**Evanswood Infrastructure Improvements  
Maple Grove, MN  
Lumen Facilities  
Reviewed by RJ Allison on 06/29/2022**

Below are the following Lumen conflicts as part of the Evanswood Infrastructure Improvements Project in Maple Grove, MN.

**LUMEN WORK PLAN**  
**PROJECT N.974575 / TERR-1006777**

SHEET NUMBER  
**C4.03**

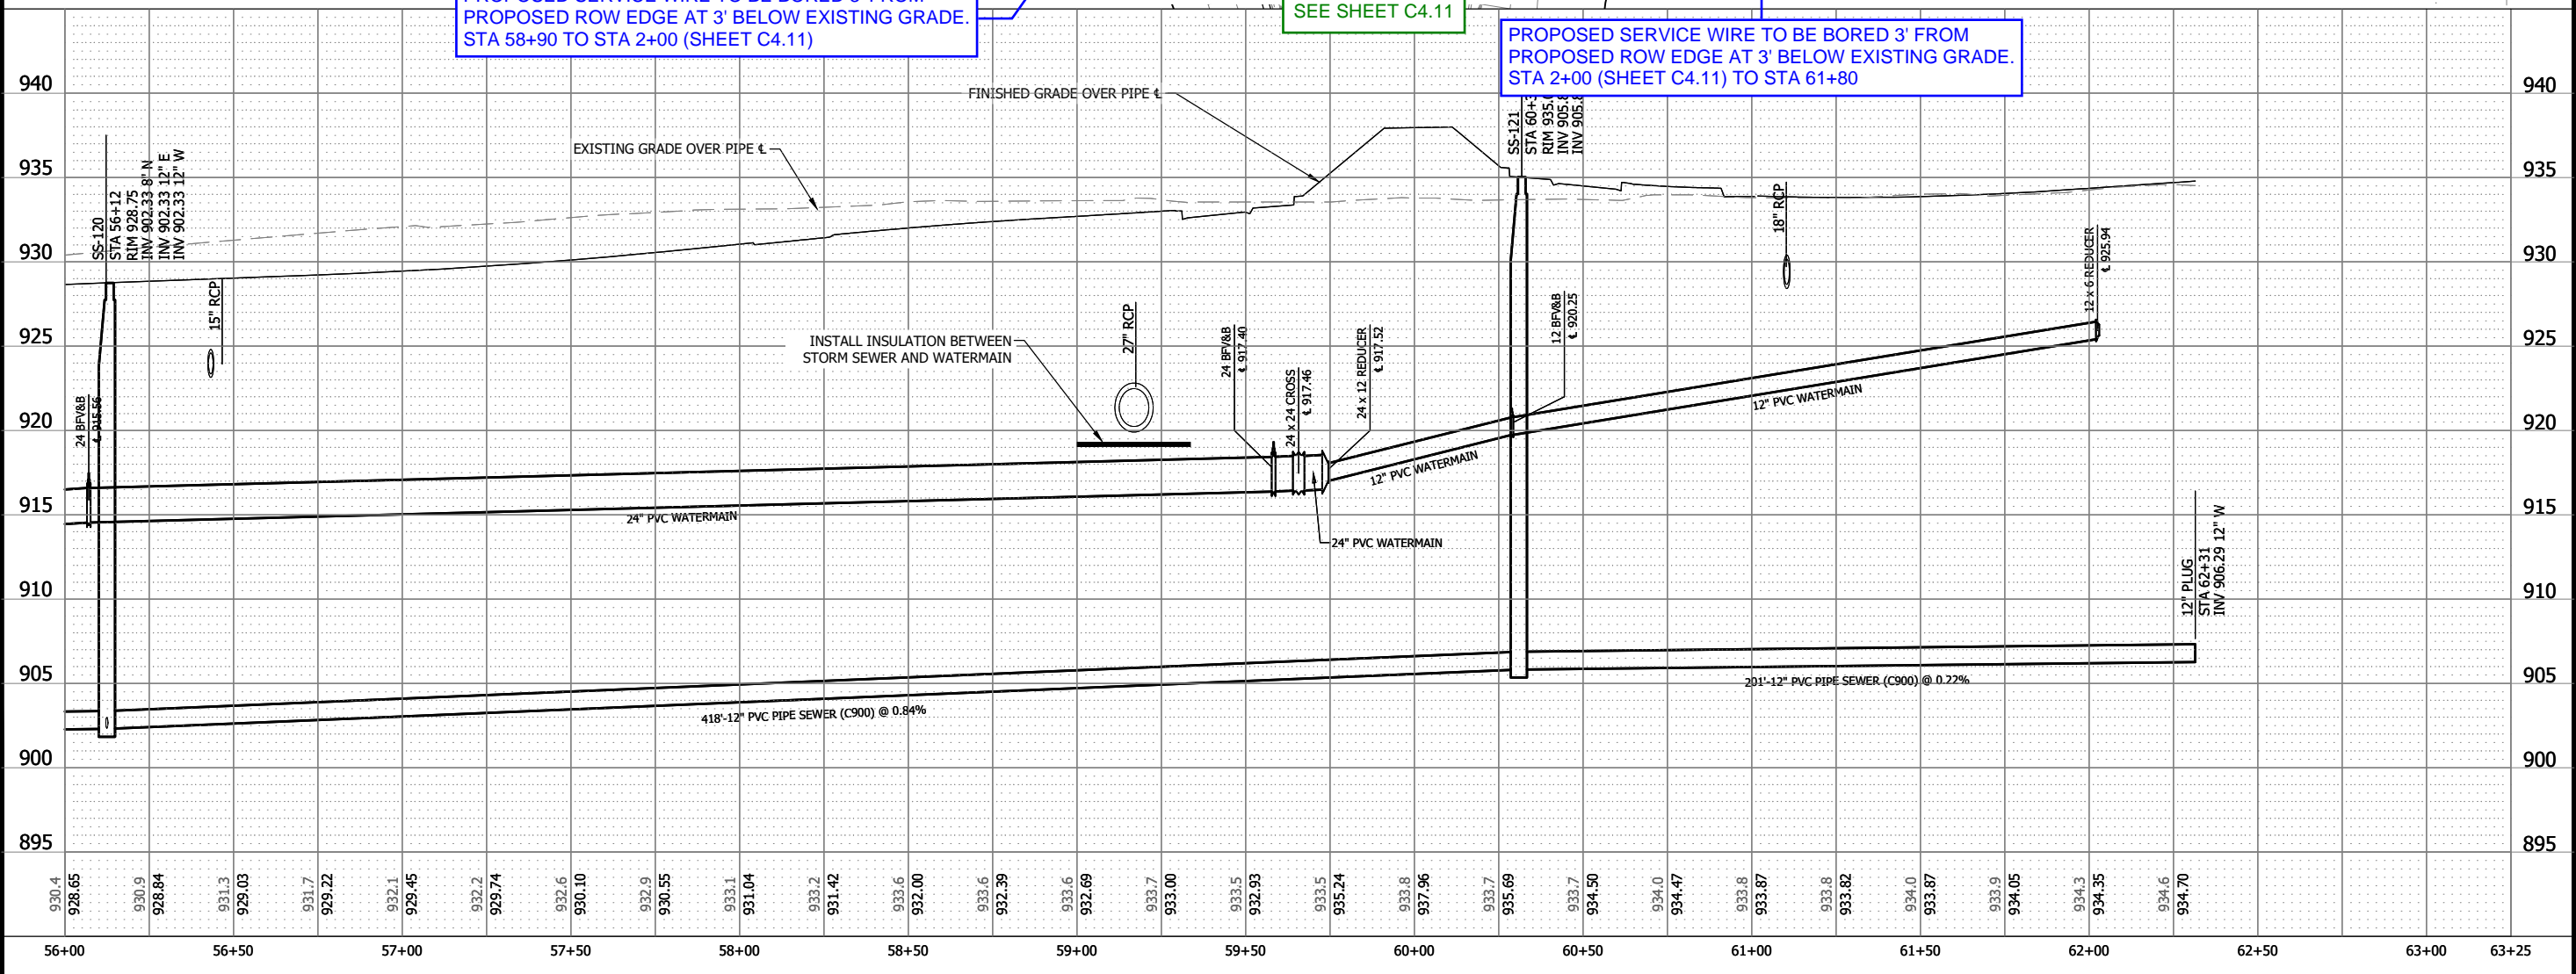
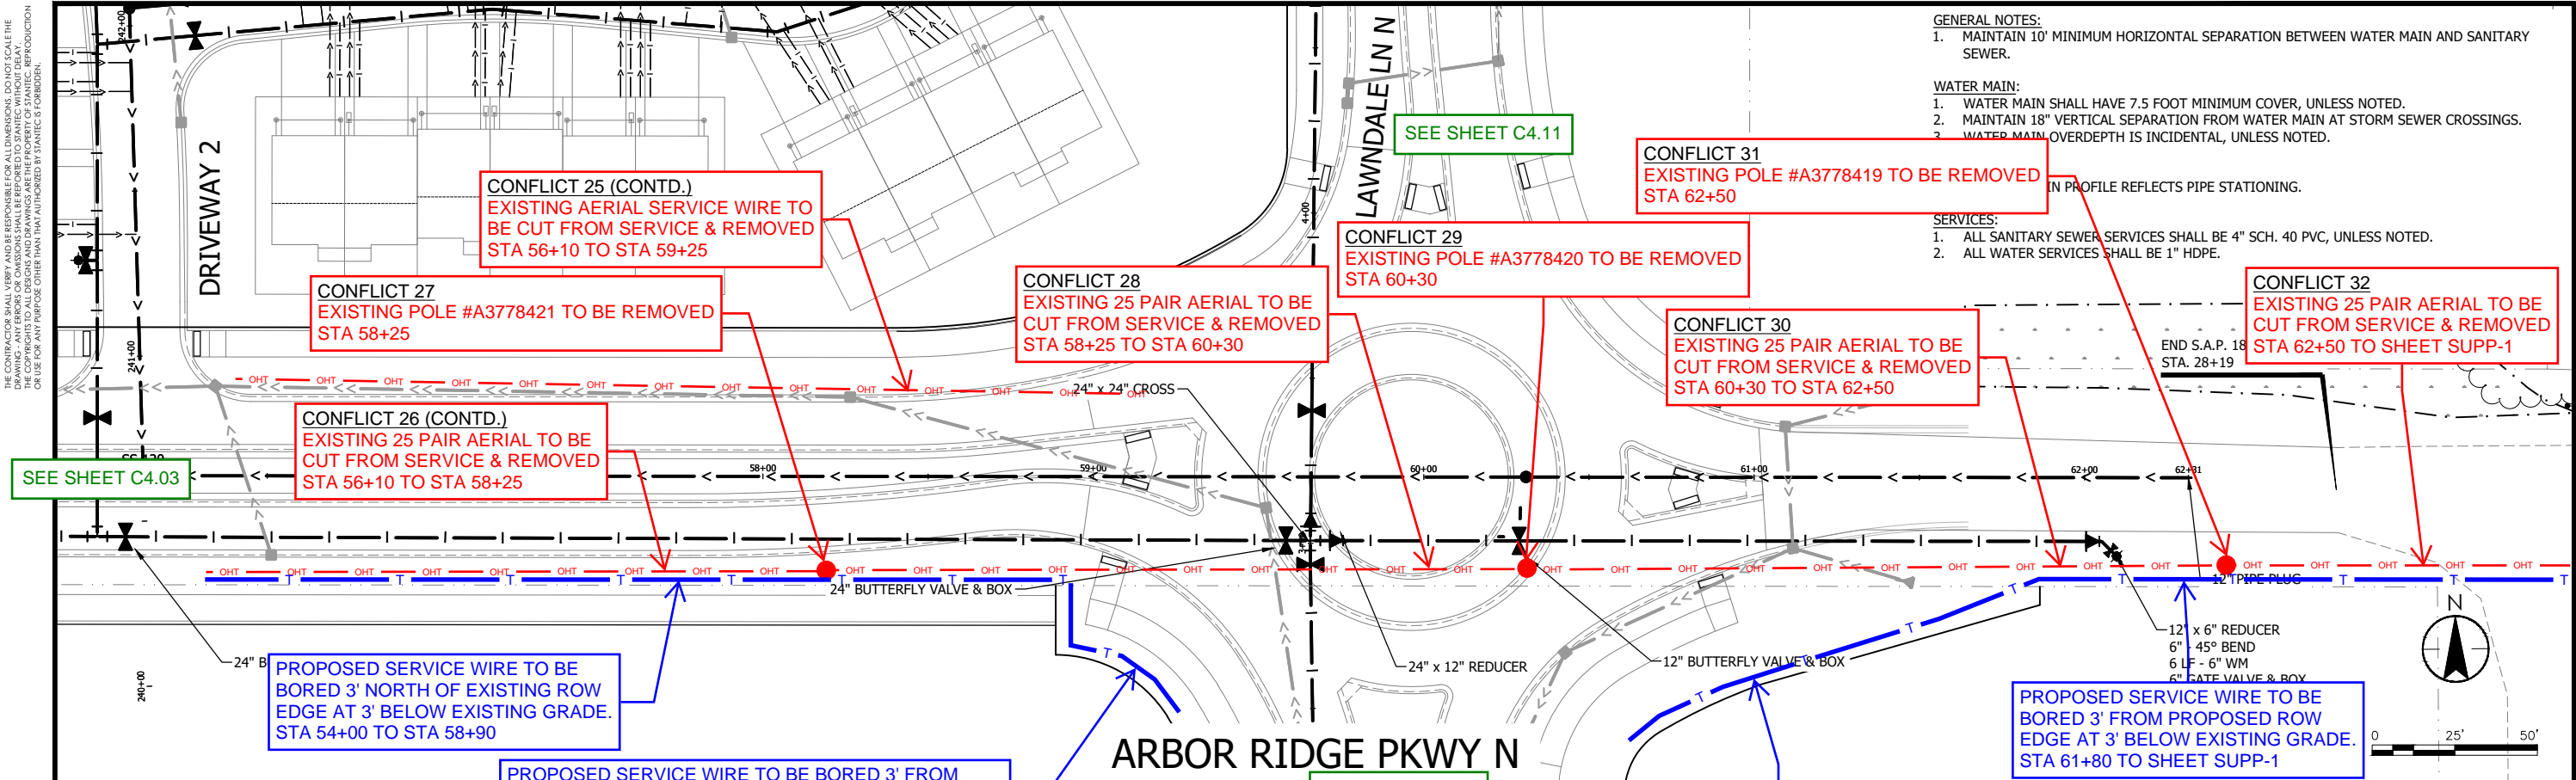
17. Arbor Ridge Pkwy (101<sup>st</sup> Ave N), STA 50+60 (RT), Sheet C4.03  
Conflict: Existing pole in conflict with proposed grading and future trail construction.  
Solution: Lumen to remove pole.

18. Arbor Ridge Pkwy (101<sup>st</sup> Ave N), STA 50+60 to STA 52+50 (RT), Sheet C4.03  
Conflict: Existing 25 pair aerial attached to Lumen poles scheduled for removal.  
Solution: Lumen to cut aerial cable from service & remove. Lumen to bore new service according to callouts and linework on work plan.

19. Arbor Ridge Pkwy (101<sup>st</sup> Ave N), STA 52+50 (RT), Sheet C4.03  
Conflict: Existing pole in conflict with proposed grading and future trail construction.  
Solution: Lumen to remove pole.

20. Arbor Ridge Pkwy (101<sup>st</sup> Ave N), STA 52+50 (RT), Sheet C4.03  
Conflict: Existing buried service wire in conflict with pole removal.  
Solution: Lumen to place new pedestal and buried service wire at STA 51+50 as shown in the work plan.

21. Arbor Ridge Pkwy (101<sup>st</sup> Ave N), STA 52+50 to STA 54+25 (RT), Sheet C4.03  
Conflict: Existing 25 pair aerial attached to Lumen poles scheduled for removal.  
Solution: Lumen to cut aerial cable from service & remove. Lumen to bore new service according to callouts and linework on work plan.

22. Arbor Ridge Pkwy (101<sup>st</sup> Ave N), STA 54+25 (RT), Sheet C4.03  
Conflict: Existing pole in conflict with proposed grading and future trail construction.  
Solution: Lumen to remove pole.

23. Arbor Ridge Pkwy (101<sup>st</sup> Ave N), STA 54+25 to STA 56+10 (RT), Sheet C4.03  
Conflict: Existing 25 pair aerial attached to Lumen poles scheduled for removal.  
Solution: Lumen to cut aerial cable from service & remove. Lumen to bore new service according to callouts and linework on work plan.

24. Arbor Ridge Pkwy (101<sup>st</sup> Ave N), STA 56+10 (RT), Sheet C4.03  
Conflict: Existing pole in conflict with proposed grading and future trail construction.  
Solution: Lumen to remove pole.

**CONFLICT 17**  
EXISTING POLE #A3778462 TO BE REMOVED  
STA 50+60

**CONFLICT 19**  
EXISTING POLE #A3778463 TO BE REMOVED  
STA 52+50

**CONFLICT 22**  
EXISTING POLE #A3778464 TO BE REMOVED  
STA 54+25

**CONFLICT 25**  
EXISTING AERIAL SERVICE WIRE TO BE CUT FROM SERVICE & REMOVED  
STA 56+10 TO STA 59+25

**CONFLICT 16 (CONTD.)**  
EXISTING 25 PAIR AERIAL TO BE CUT FROM SERVICE & REMOVED  
STA 48+80 TO STA 50+60

**CONFLICT 18**  
EXISTING 25 PAIR AERIAL TO BE CUT FROM SERVICE & REMOVED  
STA 50+60 TO STA 52+50

**CONFLICT 21**  
EXISTING 25 PAIR AERIAL TO BE CUT FROM SERVICE & REMOVED  
STA 52+50 TO STA 54+25

**CONFLICT 23**  
EXISTING 25 PAIR AERIAL TO BE CUT FROM SERVICE & REMOVED  
STA 54+25 TO STA 56+10

PROPOSED SERVICE WIRE TO BE BORED 3' NORTH OF EXISTING ROW EDGE AT 4' BELOW EXISTING GRADE.  
STA 39+50 TO STA 51+50

PROPOSED SERVICE WIRE TO BE BORED 3' NORTH OF EXISTING ROW EDGE AT 3' BELOW EXISTING GRADE.  
STA 54+00 TO STA 58+90

**CONFLICT 24**  
EXISTING POLE #A3778465 TO BE REMOVED  
STA 56+10

**CONFLICT 26**  
EXISTING 25 PAIR AERIAL TO BE CUT FROM SERVICE & REMOVED  
STA 56+10 TO STA 58+25

**CONFLICT 20**  
EXISTING BURIED SERVICE WIRE TO BE CUT FROM SERVICE & LEFT IN PLACE  
STA 52+50

PROPOSED SERVICE WIRE TO BE BORED 3' NORTH OF EXISTING ROW EDGE AT 4' BELOW EXISTING GRADE. BORE ACROSS CREEK AT 10' BELOW EXISTING CREEK BOTTOM.  
STA 51+50 TO STA 54+00

SHEET NUMBER  
**C4.04**

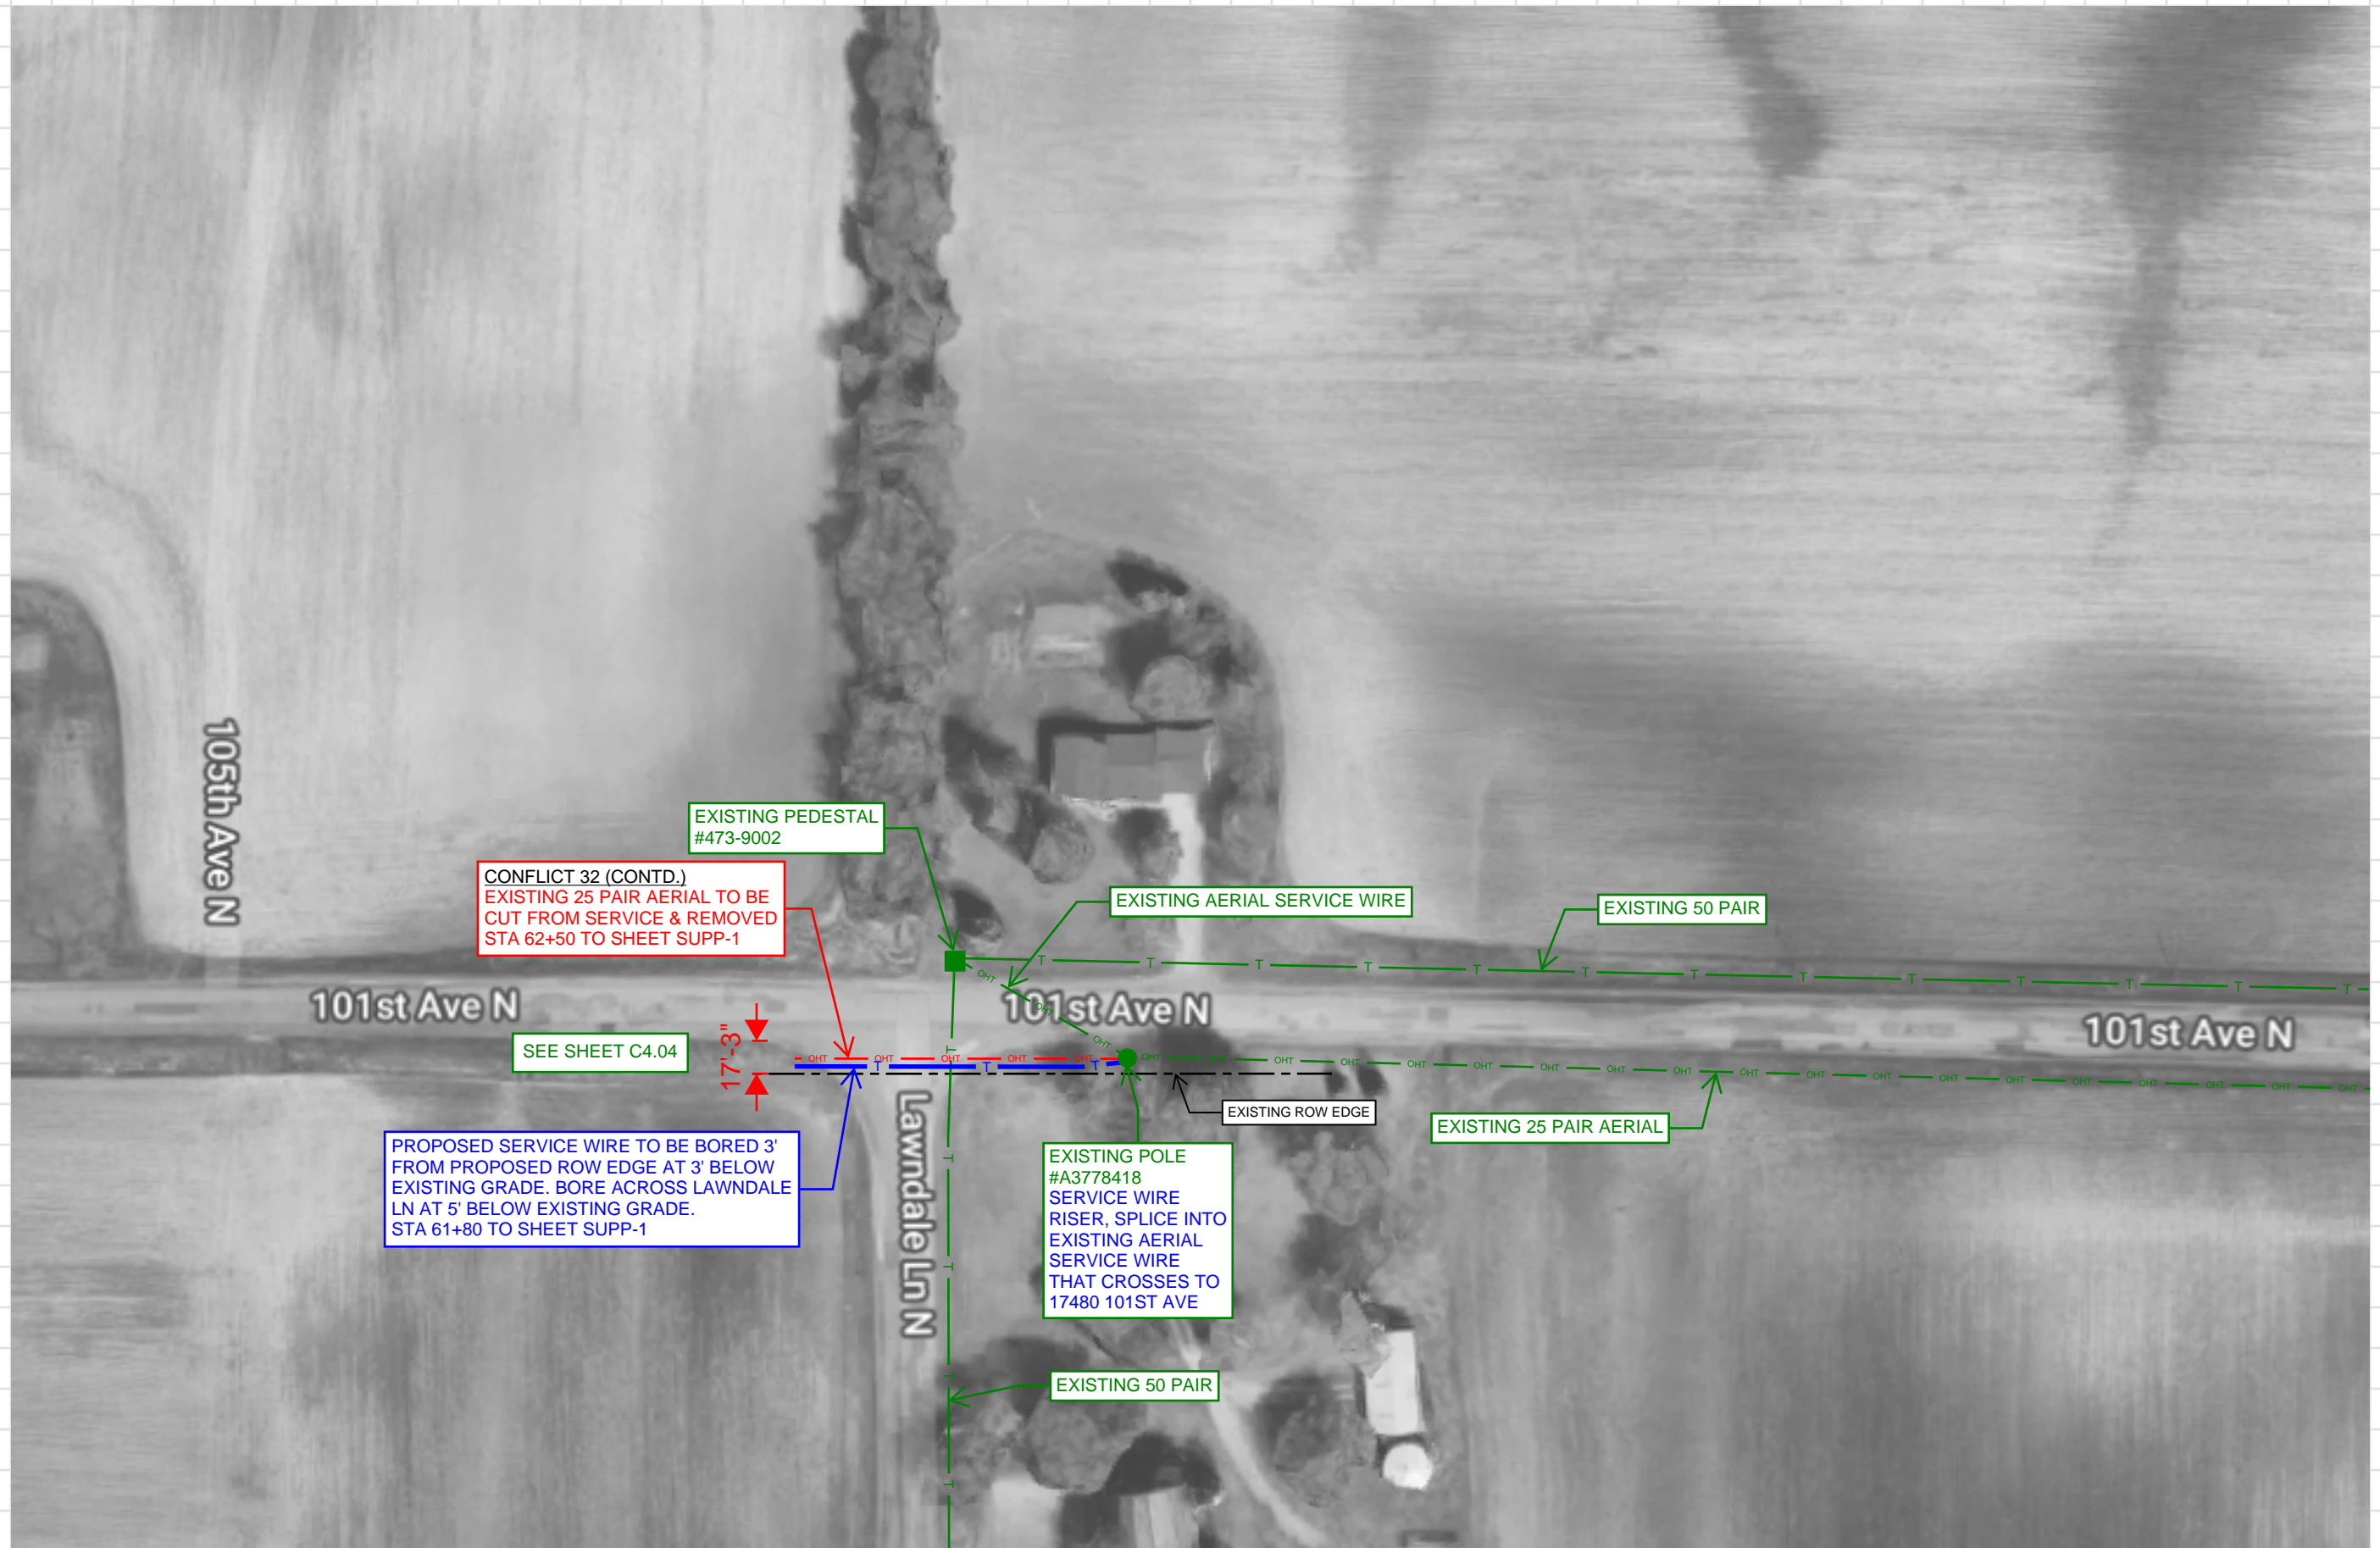
25. Arbor Ridge Pkwy (101<sup>st</sup> Ave N), STA 56+10 to STA 59+25 (LT to RT), Sheet C4.03 to C4.04  
Conflict: Existing aerial service wire attached to Lumen and Xcel poles scheduled for removal.  
Solution: Lumen to cut aerial cable from service & remove.

26. Arbor Ridge Pkwy (101<sup>st</sup> Ave N), STA 56+10 to STA 58+25 (RT), Sheet C4.03 to C4.04  
Conflict: Existing 25 pair aerial attached to Lumen poles scheduled for removal.  
Solution: Lumen to cut aerial cable from service & remove. Lumen to bore new service according to callouts and linework on work plan.

27. Arbor Ridge Pkwy (101<sup>st</sup> Ave N), STA 58+25 (RT), Sheet C4.04  
Conflict: Existing pole in conflict with proposed grading and future trail construction.  
Solution: Lumen to remove pole.

28. Arbor Ridge Pkwy (101<sup>st</sup> Ave N), STA 58+25 to STA 60+30 (RT), Sheet C4.04  
Conflict: Existing 25 pair aerial attached to Lumen poles scheduled for removal.  
Solution: Lumen to cut aerial cable from service & remove. Lumen to bore new service according to callouts and linework on work plan.

29. Arbor Ridge Pkwy (101<sup>st</sup> Ave N), STA 60+30 (RT), Sheet C4.04  
Conflict: Existing pole in conflict with proposed roundabout.  
Solution: Lumen to remove pole.

30. Arbor Ridge Pkwy (101<sup>st</sup> Ave N), STA 60+30 to STA 62+50 (RT), Sheet C4.04  
Conflict: Existing 25 pair aerial attached to Lumen poles scheduled for removal.  
Solution: Lumen to cut aerial cable from service & remove. Lumen to bore new service according to callouts and linework on work plan.

31. Arbor Ridge Pkwy (101<sup>st</sup> Ave N), STA 62+50 (RT), Sheet C4.04  
Conflict: Existing pole in conflict with proposed grading and future trail construction.  
Solution: Lumen to remove pole.

32. Arbor Ridge Pkwy (101<sup>st</sup> Ave N), STA 62+50 to Sheet Supp-1 (RT), Sheet C4.04 to Supp-1  
Conflict: Existing 25 pair aerial attached to Lumen poles scheduled for removal.  
Solution: Lumen to cut aerial cable from service & remove. Lumen to bore new service according to callouts and linework on work plan.
